TECHNICAL NOTE

File Ref: P21-2187

Subject: **Grant Family – Deadline 3 Response**

Figure 2.1 –Fordley Hall Farm Dissected by SLR

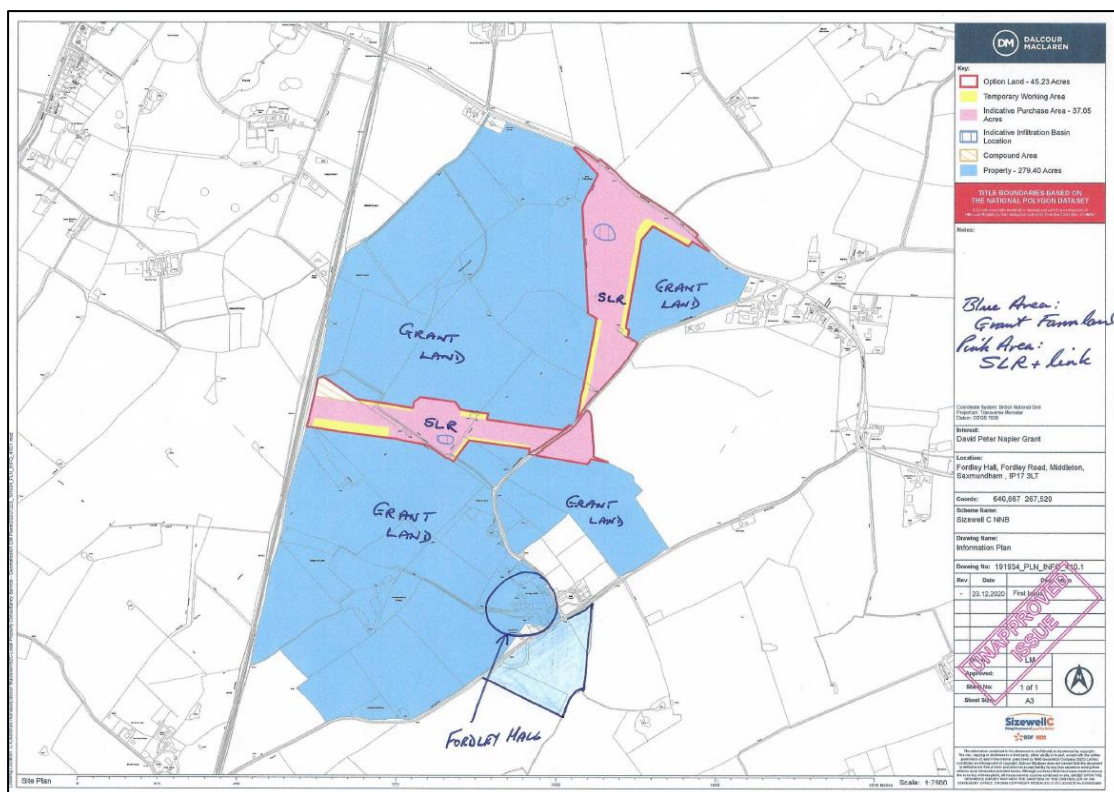
- 2.2 The concluding point from the Create DL2 submission considered the closure of Fordley Road as fundamentally flawed, severing several communities, as well as local residents of Middleton cum Fordley from important services, disrupting the Grant's and other local farming operations. This effect creates a potential rat run to the A12. All of which fail to deliver the legacy benefits promoted by the Applicant.

- 2.3 The removal of the SLR junction to Fordley Road south and the reinstatement of the Fordley Road connection whether by overbridge or underpass are therefore considered essential.

2.7 Fordley Road and the landowner severance is as bad, if not worse, than Pretty Road.
